Westside Purple Line Extension Project, Section 3

Addendum to the Final Environmental Impact Report

June 2018

Figure 2-2: Construction Staging Areas – Final EIS/EIR and Proposed

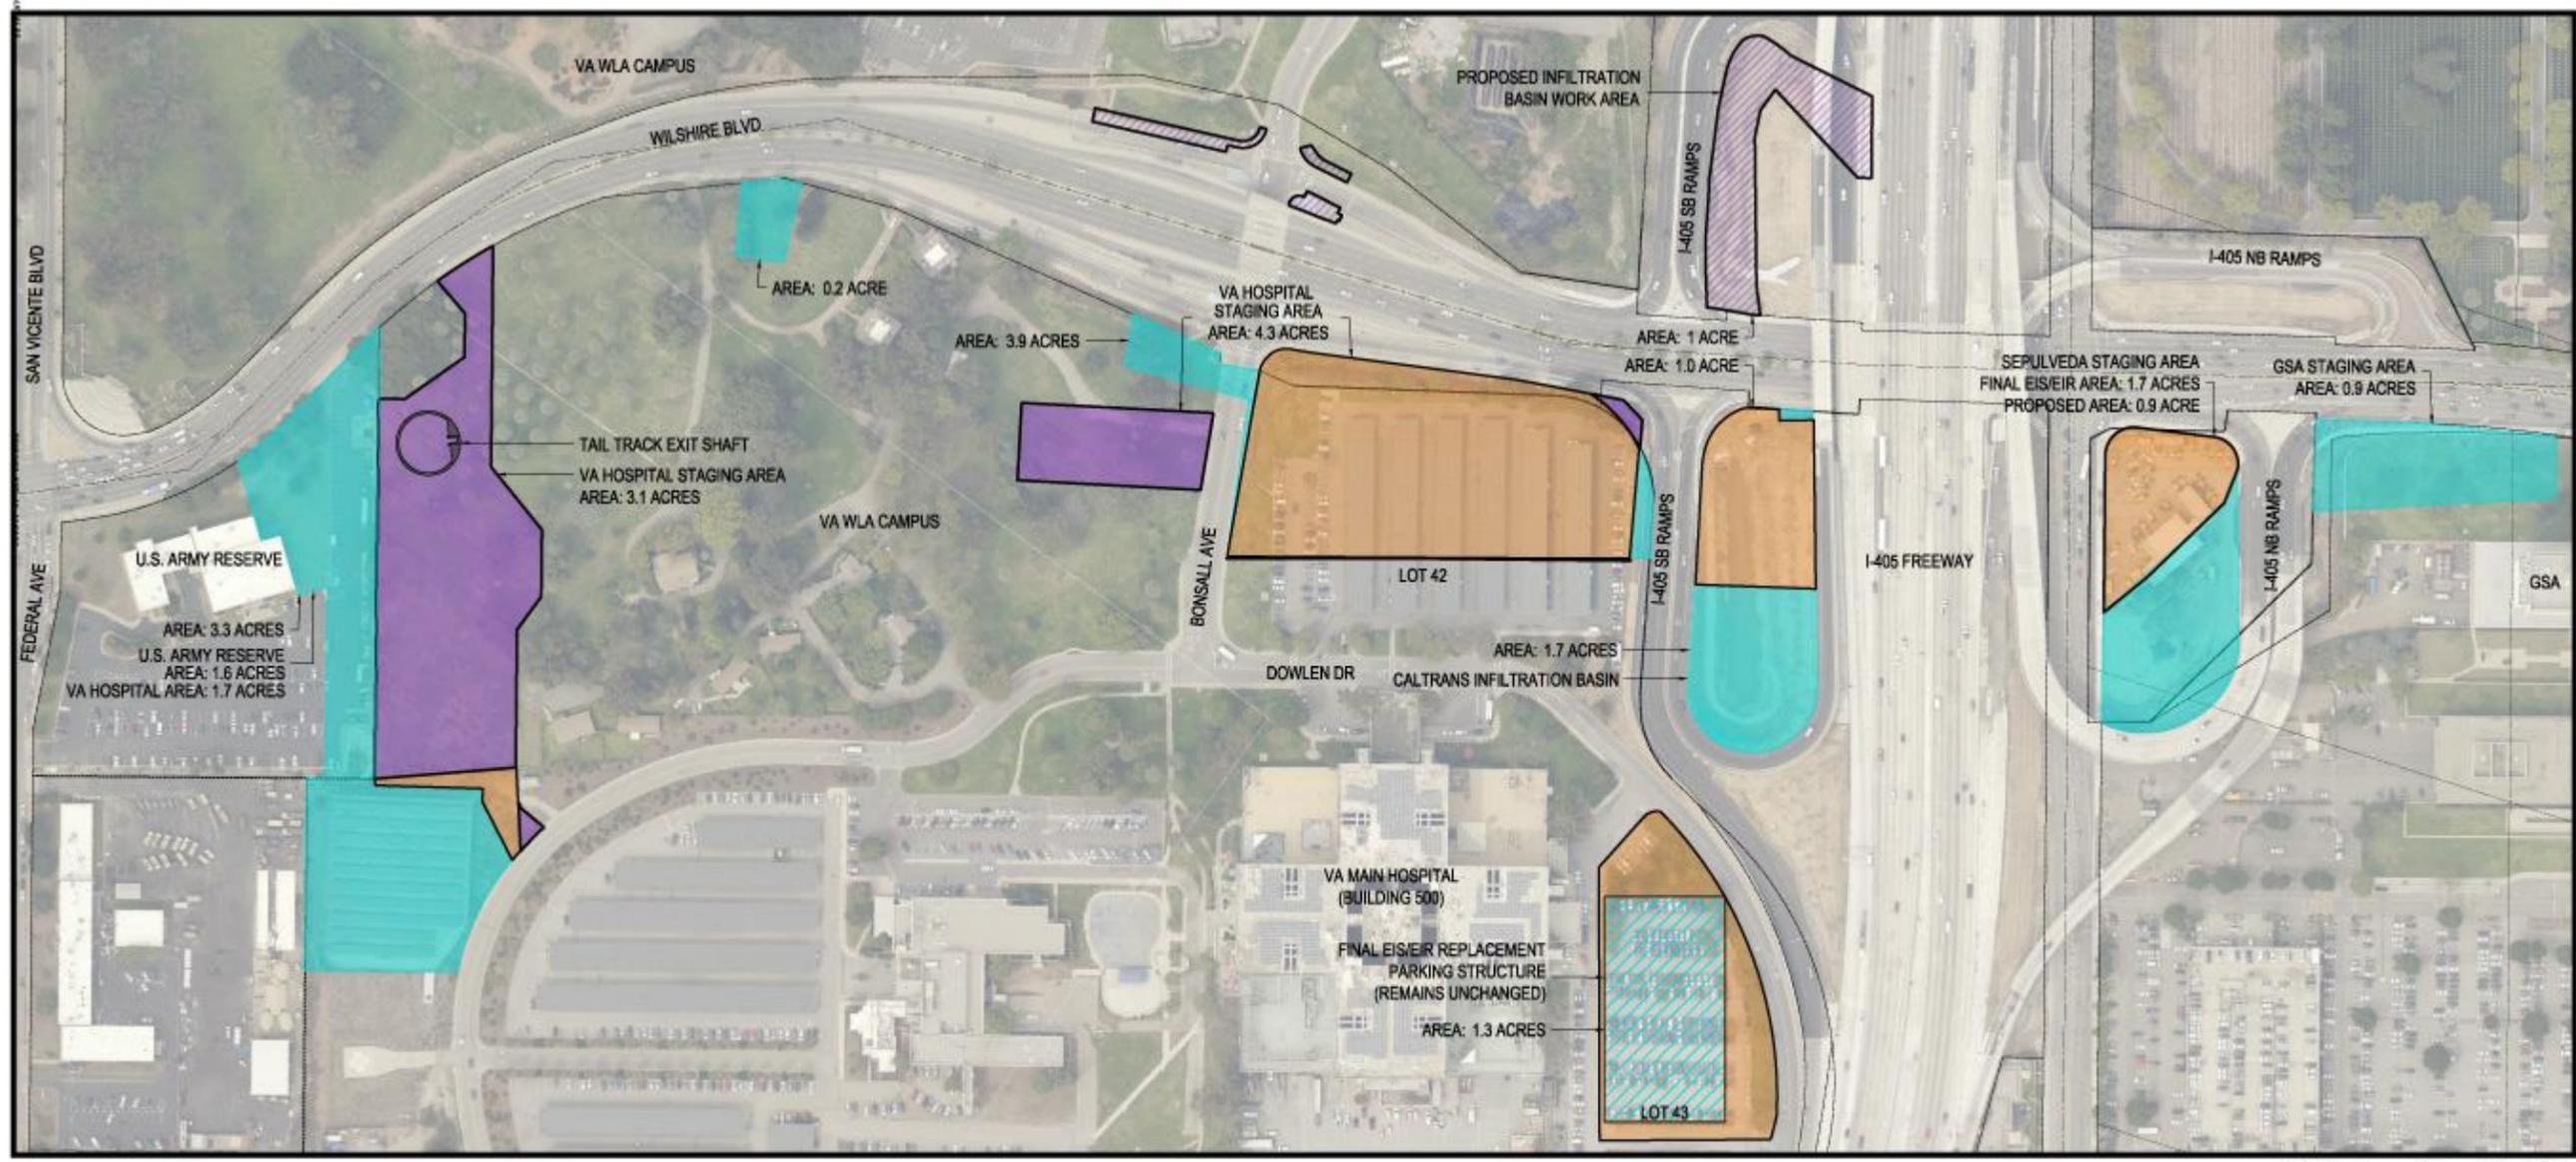
The construction staging areas identified on or in proximity to the Veterans Affairs West Los Angeles Campus (VA WLA Campus) have been refined since issuance of the Final EIS/EIR (Metro 2012a). The locations of the construction staging areas in the Final EIS/EIR and the refined construction staging areas adjacent to and west of I-405 are shown in Figure 2-2. The following sections summarize the refinements to construction staging areas west of I-405.

The Final EIS/EIR also included a construction staging area within a Caltrans infiltration basin (a stormwater Best Management Practice) located south of Wilshire Boulevard and bounded by the I-405 raised west embankment and the I-405 southbound off-ramp to Wilshire Boulevard. The size of this construction staging area has been reduced since issuance of the Final EIS/EIR from 1.7 acres to 1 acre as a result of a consolidated construction staging area and design refinement. The approximately 1 acre site is shown in Figure 2-2.

During the advancement of design, it was determined that the Caltrans infiltration basin located north of Wilshire Boulevard and bounded by I-405 and the on-ramp to southbound I-405 would require modifications to replace the volume of water displaced by construction within the south basin. Modifications include excavation and backfill with permeable material, as well as storm drain diversions. The approximately 1 acre site is shown in Figure 2-2.

A construction staging area west of Bonsall Avenue is also required to construct the west crossover and west end of the station box (refer to Section 2.2 for a description of the change in location of the station box and Section 2.5 for a description of the construction method for the west crossover). Very limited construction traffic (approximately 20 vehicles per day) is proposed in this staging area; the contract documents require that the site not be used for storage of diesel engine equipment, for contractor parking, or for construction facilities such as trailers. The staging area is approximately 10 feet wider than the station piled walls and approximately 300 feet long. During excavation of the station in this area, it is expected that the excavation would be open and limited vehicular traffic would enter the site. The approximately 1 acre site is shown in Figure 2-2.

Figure 2-4: Tunnel and Crossover Alignment at the VA Medical Center – Final EIS/EIR and Proposed

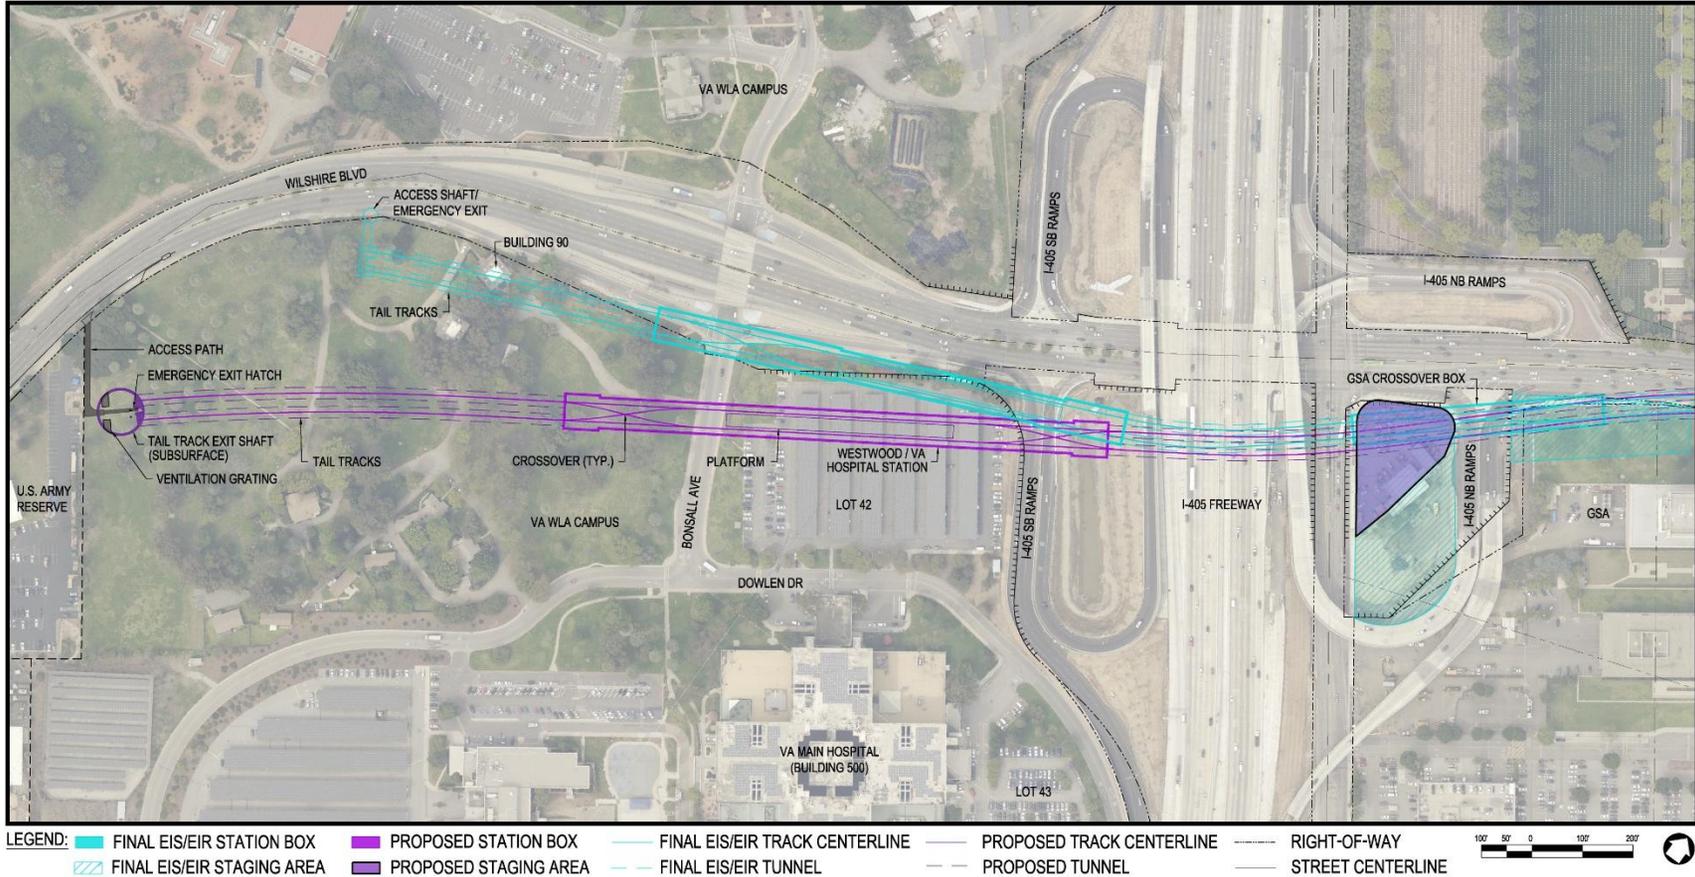
Within proximity to the Westwood/VA Hospital Station, the alignment as evaluated in the Final EIS/EIR contained several smaller radius (tighter) curves and an east crossover structure (referred to as the GSA [General Services Administration] crossover) within the GSA property east of I-405 (a crossover is specialized trackwork that allows a train to reverse direction and use an adjacent track to continue operation). Metro Rail Criteria requires that a terminal station includes two crossovers, before and after the station and therefore there is also a west crossover attached to the west end of the platform. Through the advancement of design, the curves in the alignment have been minimized to improve operating conditions for a future transit extension from the Westwood/VA Hospital Station. The Final EIS/EIR and refined alignments are shown in Figure 2-4. In the Final EIS/EIR, the tail tracks were situated in tunnels directly beneath a contributing element to the West Los Angeles Veterans Affairs Historic District (WLA VA Historic District), referred to as Building 90: Duplex. As a result of the refinement to the alignment, the tail track tunnels are no longer situated beneath any building within the VA WLA Campus or the WLA VA Historic District (Figure 2-4).

The refinement to the alignment would accommodate an east crossover directly east of the Westwood/VA Hospital Station and partly within the Caltrans infiltration basin, which would be connected to the station platform (this crossover is referred to as the East Crossover at the VA Campus). This location for this crossover is operationally preferred by Metro compared to the GSA crossover because the crossover is located closer to the station platform. With this refinement, the GSA crossover would be eliminated and a cross passage within Caltrans right-of-way east of I-405 would be added (the Project is constructed as two tunnels; a cross passage is a small passageway that connects those tunnels to provide egress in the case of fire or another emergency). Placement of the cross passage off-street in this location minimizes impacts to Wilshire Boulevard and the I-405 northbound ramps. The Final EIS/EIR included two construction staging areas for construction of the GSA crossover—one on GSA property and the other within Caltrans right-of-way in an area bounded by Wilshire Boulevard to the north and the I-405 northbound ramps (Figure 2-4). The construction staging area on the GSA property would be eliminated completely because all construction on the GSA property would occur from underground. The construction staging area within Caltrans right-of-way would no longer be required to support construction at the GSA property; however, this staging area would be used for construction of the cross passage, necessary grout injection to support utilities beneath Sepulveda Boulevard (refer to Section 2.8), and as a staging site for advance utility relocations. The overall size of this Caltrans staging area has been reduced from 1.72 acres to 0.94 acre (a 0.78-acre reduction) because these construction activities can be accommodated on a smaller staging area than what was required for the crossover. Minimizing construction on the GSA property would benefit the Project and the GSA as there would be less disruption, noise and vibration, haul routes, and traffic in front of the building.

Figure 2-5: Westwood/VA Hospital Station Entrances and Pedestrian Circulation Features – Final EIS/EIR and Proposed

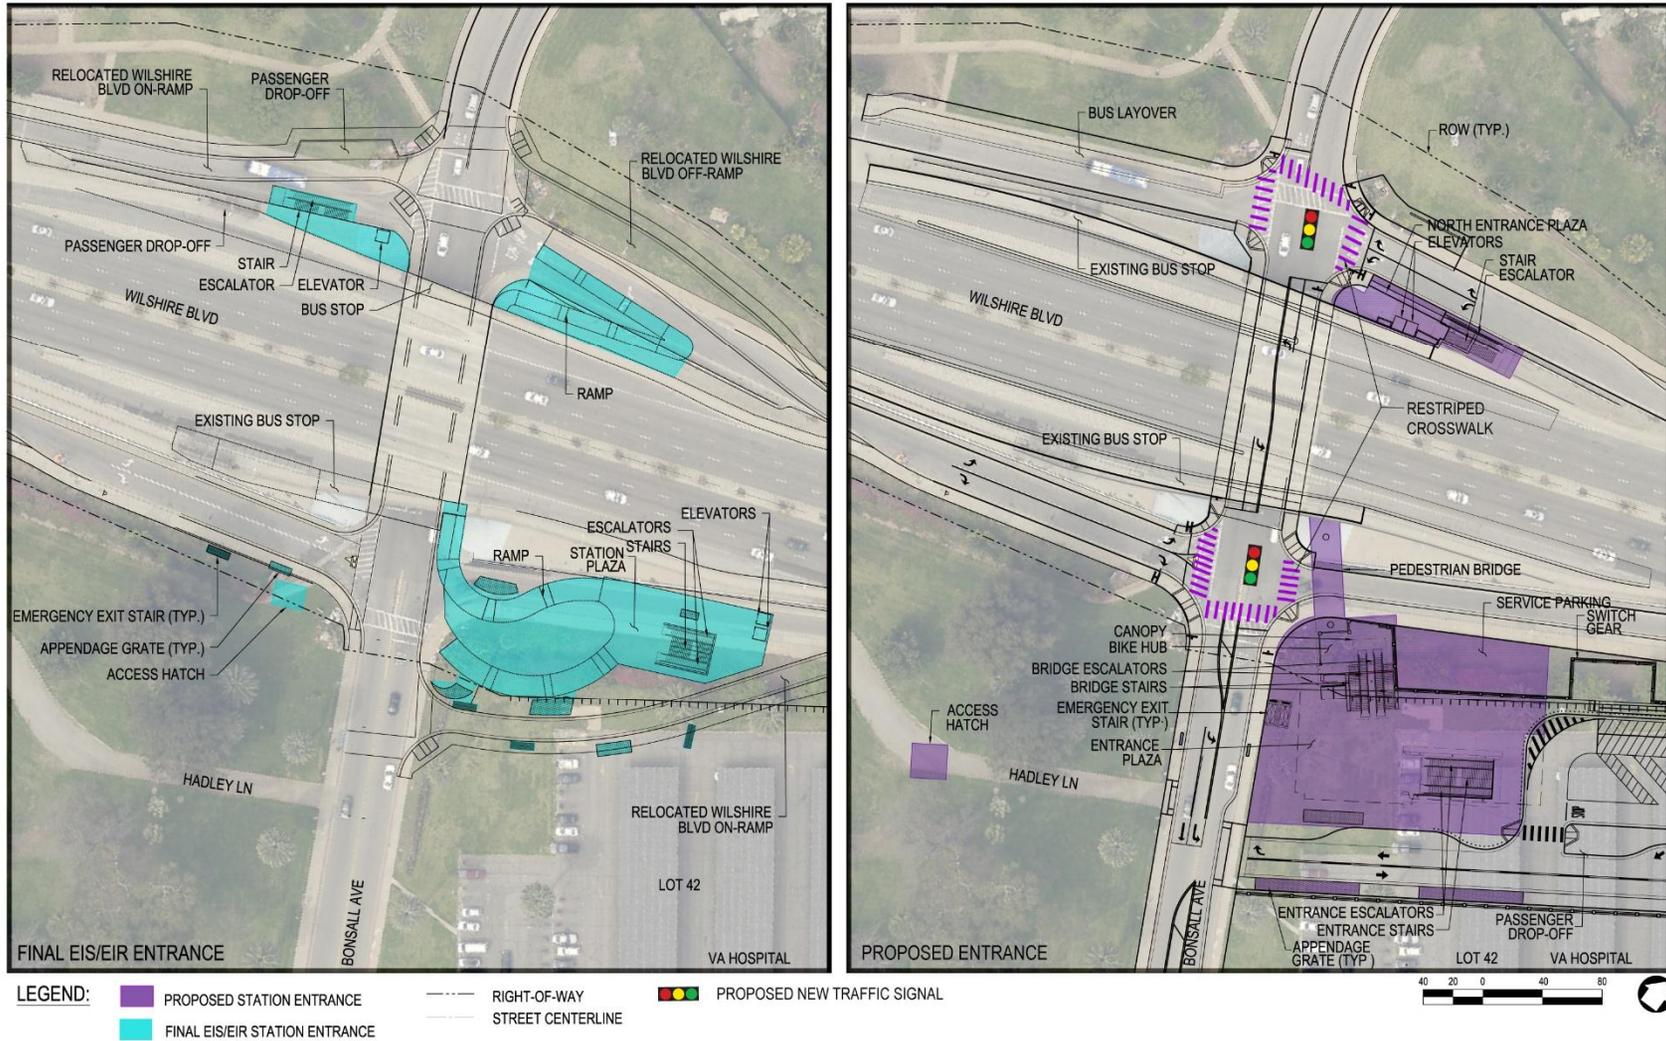
As a result of the refinement to the alignment, the alignment and station box have been shifted south by approximately 150 feet away from Wilshire Boulevard. The alignment and station box would continue to be located beneath the existing parking lot on the VA WLA Campus. The station box has been moved west, beneath the WLA VA Historic District, by approximately an additional 150 feet as a result of the crossover being added to the east side of the platform. The station box and crossover cannot be moved east because open-cut construction would require closure of portions of I-405. Metro Operations does not favor a separated station box with portions moved east of the I-405. Additionally, this design would reduce the design headways and the ability of trains to turn around at the terminal station. It is not favorable to move the station to the west, as this pushes it farther into the WLA VA Historic District and closer to contributing elements within the district. The shift in the station box required refinements to the station entrance and pedestrian circulation features. With this refinement, the station entrance would be located approximately 100 feet closer to the VA Main Hospital (Building 500), benefitting transit passengers, including veterans and employees, with destinations at this facility. Additionally, the pedestrian circulation features between the station entrance and Wilshire Boulevard would be less circuitous than those included in the Final EIS/EIR design. New vertical circulation elements (elevators and escalators) would be included, thus improving passenger connectivity, particularly for patrons with disabilities (Figure 2-5).

The refinements to the station entrance and pedestrian circulation features would also eliminate the need to reconfigure the access ramps on both sides of Wilshire Boulevard and reduce the impact to the Bonsall Avenue and access ramps intersection. Reconfiguration of the access ramp on the east side of Bonsall Avenue is no longer required; therefore, the pedestrian ramp in the Final EIS/EIR has been replaced with a pedestrian bridge compliant with the Americans with Disabilities Act (ADA) to provide access from the Westwood/VA Hospital Station entrance to the bus stop on eastbound Wilshire Boulevard (Figure 2-5). These refinements are being coordinated with representatives of the VA WLA Campus.
